PROJECT: Westcliff Pines 2

CITY OF LAS VEGAS		DATE:
INTER-OFFICE MEMORANDUM		March 22, 2012
TO: Land Development Services Department of Public Works		FROM: Albert Sung, P.E. Flood Control Project Engineer Department of Public Works
SUBJECT:	Drainage Study for:	
	Westcliff Pines 2	
Cross Streets:	SEQ of Summerlin Pkwy. & Durango Drive	
File Number:	F:\Depot\DSMemos\DS4550B.doc	
Parcel Number:	138-28-401-015	
Zoning Action:	SDR-44166	
FEMA Flood Zone	YES	NO X
Proposed Storm Drain	YES	NO X
COPIES TO:		
		L.R. Nelson Consulting Engineers
		HAND Property Holding Company
		Bart Anderson, P.E., DevCo

We have received the City of Las Vegas Inter-Office Memorandum review comments for the above-mentioned study, dated February 23, 2012. The comments are re-stated below along with the corresponding response.

SHEET GR1

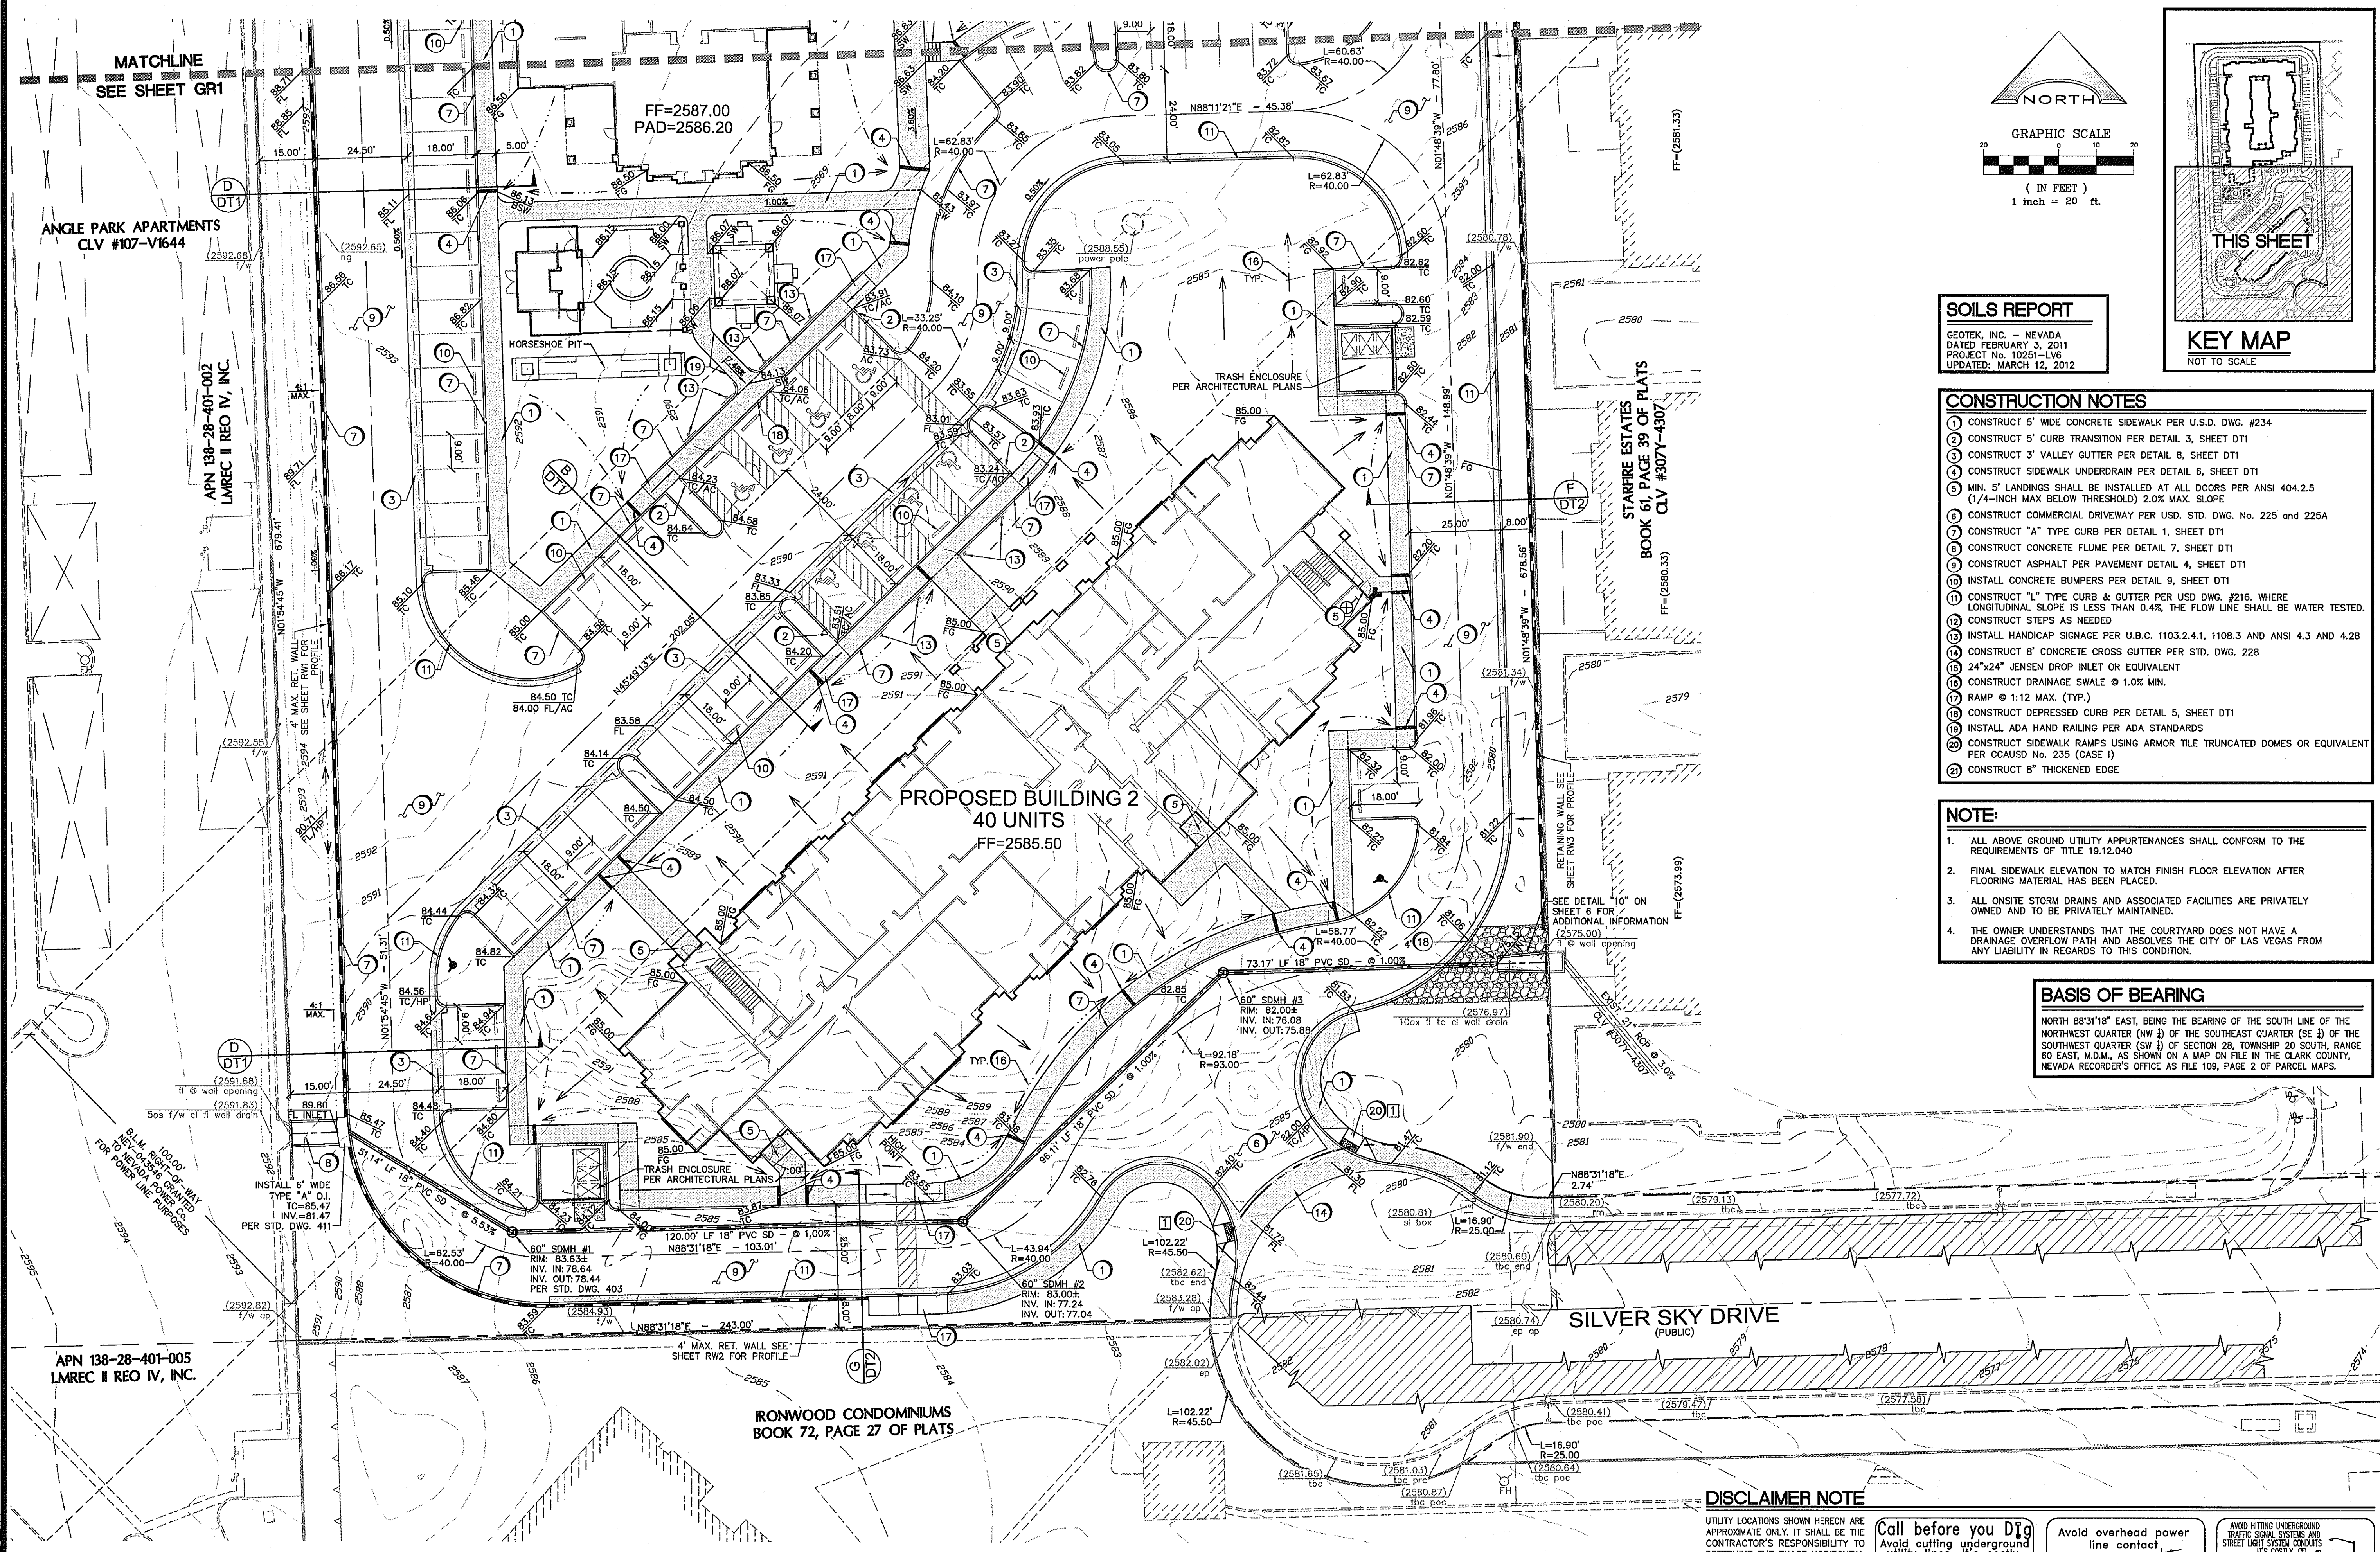
4. **Sheet GR1:** At the NWC flume inlet, the energy head (per calculation) is 4.64' which will cause the discharge to splash over to the interior driveway before it can be collected into the drop inlet. Provide an apron or wing structure or something equivalent to prevent the splash over to the adjacent driveway. Review and revise accordingly.

5. **Sheet GR1:** Provide a swale in the 15'-landscape strip along the west boundary and bring the flow to the proposed drop inlet for discharge.

6. **Sheet GR1:** Identify an overflow path in the courtyard area in a worst case scenario that the two proposed Jensen grate inlets become completely clogged.

7. **Sheet GR1:** Identify an existing drain in the adjacent property to the east (*Starfire Estates*) and label with *City of Las Vegas* recorded construction plan number.

8. **Sheet GR1:** Provide a connection detail for the new and existing storm drains at the interface of subject property and the *Starfire Estates*.

On Wednesday, February 29, 2012, a meeting was held at the City of Las Vegas Flood Control Section in the 7th floor conference room to discuss the comment. In attendance at the meeting were, Albert Sung, P.E., Flood Control Section Project Engineer, City of Las Vegas, Richard Turner, Civil Engineering Department Manager and Jon Hayslip, P.E., L. R. Nelson Consulting Engineers. At this meeting, L. R. Nelson Consulting Engineers discussed the issue and explained since the offsite storm water entering the flume originates on private property and will be conveyed into a privately maintained system that any of the overflow splash will be landing within the privately maintained onsite drive aisle. We also discussed Comment #3 that the City of Las Vegas required the additional note to be placed on the improvement plans that indicate all privately constructed flood control facilities will be privately maintained. Also, it was agreed upon to provide a one (1) foot wall along the boundaries flume to provide splash protection for the flood control facility. The enclosed improvement plans have been revised accordingly.

The grading has been revised to provide a swale in the 15'-landscape strip along the west boundary and bring the flow to the proposed drop inlet for discharge.

At the meeting held at the City of Las Vegas on Wednesday, February 29, 2012, it was discussed the area is enclosed by the building and courtyard area does not have an available overflow path. L. R. Nelson Consulting Engineers proposed to add two (2) additional 2-ft by 2-ft Jensen Precast inlets and connecting 18-in pipe to provide additional or redundant inlets to pick up the courtyard area storm runoff. Based upon this discussion, Mr. Sung concurred with this recommendation. The enclosed improvement plans have been revised accordingly.

The City of Las Vegas recorded construction plan number is now shown on Grading Sheet GR1.

A connection detail for the new and existing storm drains at the interface of subject property and the *Starfire Estates* has been provided for the reference made on Sheet GR1.

GRADING PLAN 2

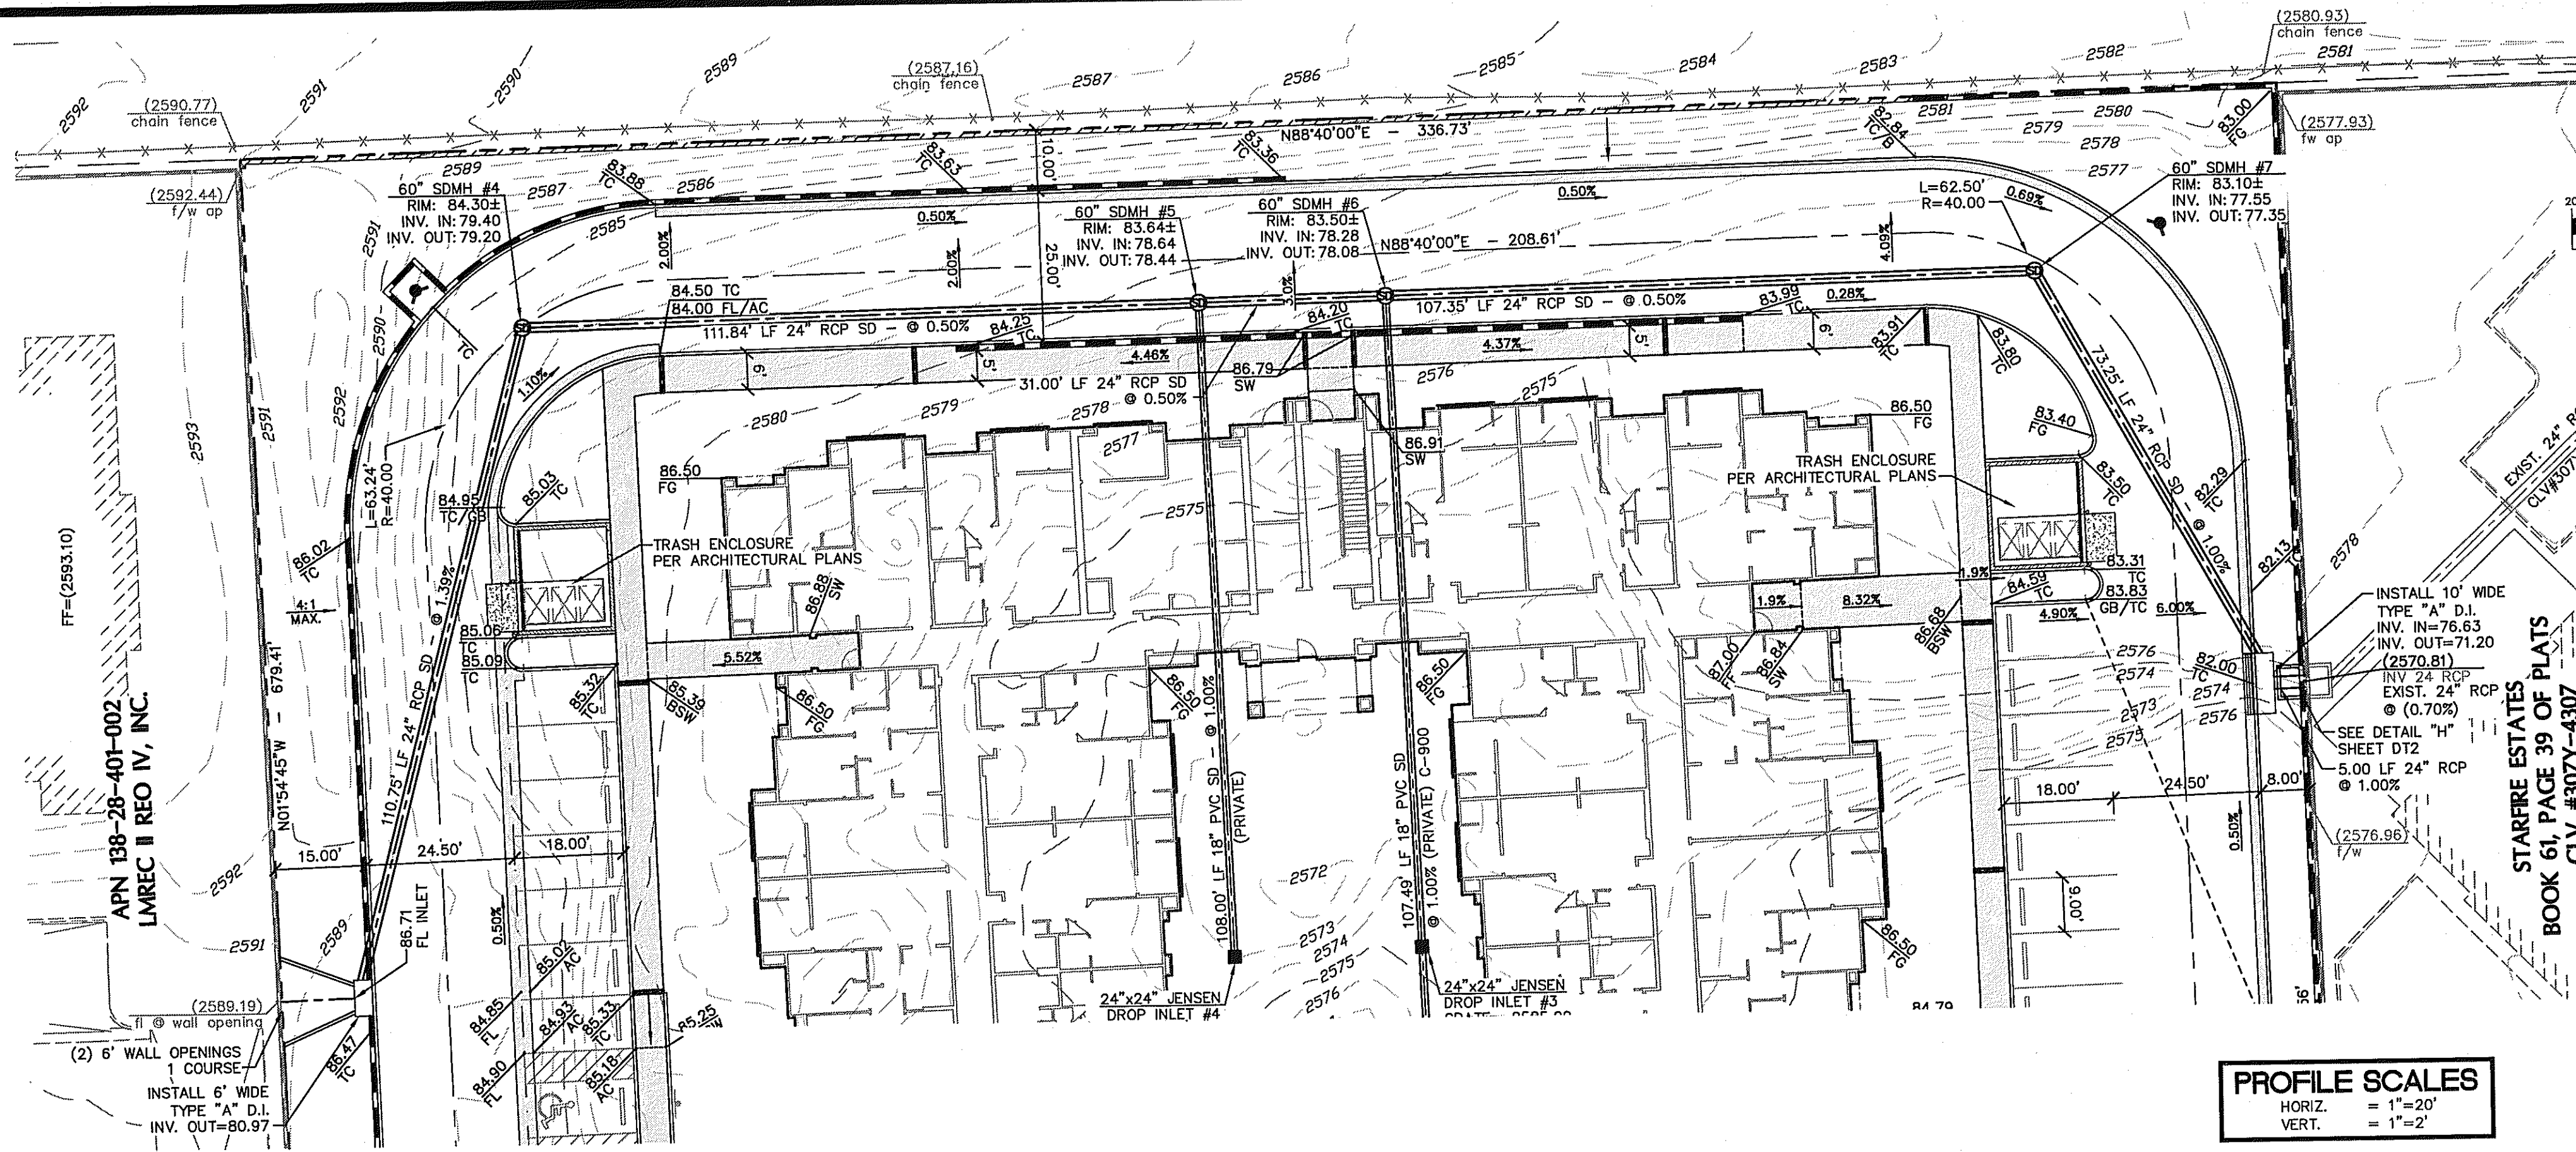
9. **Sheet GR2:** Reference Comment #4 at the SWC flume inlet.

10. **Sheet GR2:** Reference Comment #5.

11. **Sheet GR2:** Reference Comment #7 at the southeast corner of the site.

The proposed design changes for the flume inlet at the SWC will be resolved as described in the response to Comment #4.

The grading has been revised to provide a swale in the 15'-landscape strip along the west boundary and bring the flow to the proposed drop inlet for discharge.

The City of Las Vegas recorded construction plan number is now shown on Grading Sheet GR2.

Detail Section B is located on Sheet GR2 on the enclosed improvement plans.

STORM DRAIN PLAN and PROFILE 1	
WESTCLIFF PINES 2 ROLAND WILEY ROAD and SILVER SKY DRIVE CITY OF LAS VEGAS

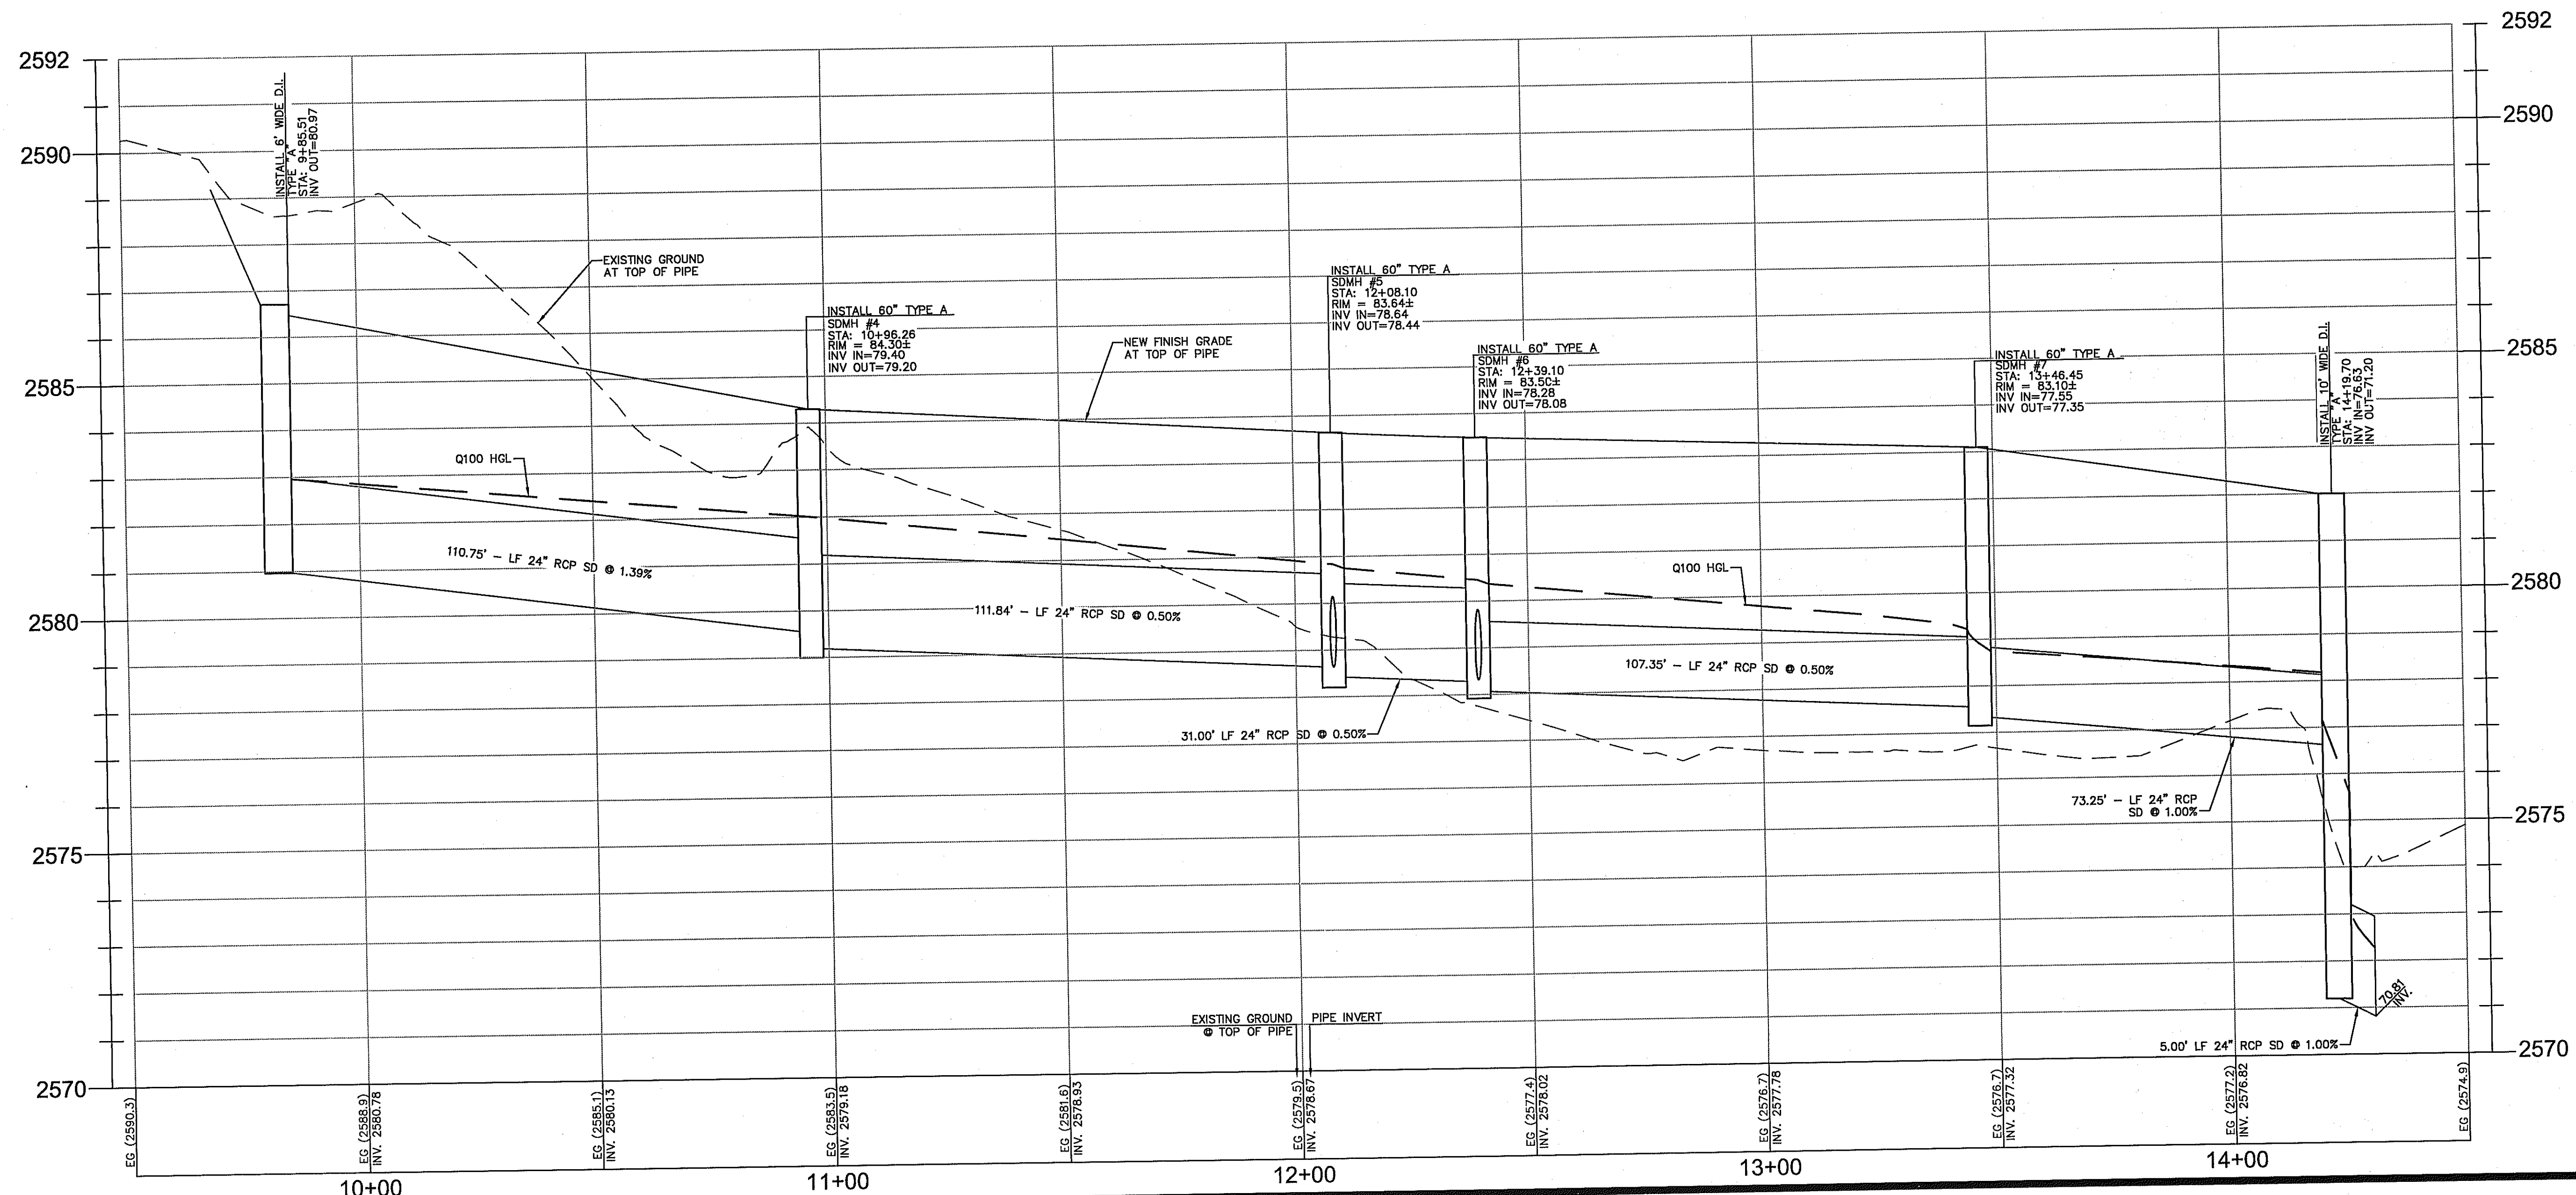
12. **Sheet SD1:** As stated in Comment #8, provide a connection detail in the plan view and profile section.

A connection detail has been provided as requested on sheet SD1.
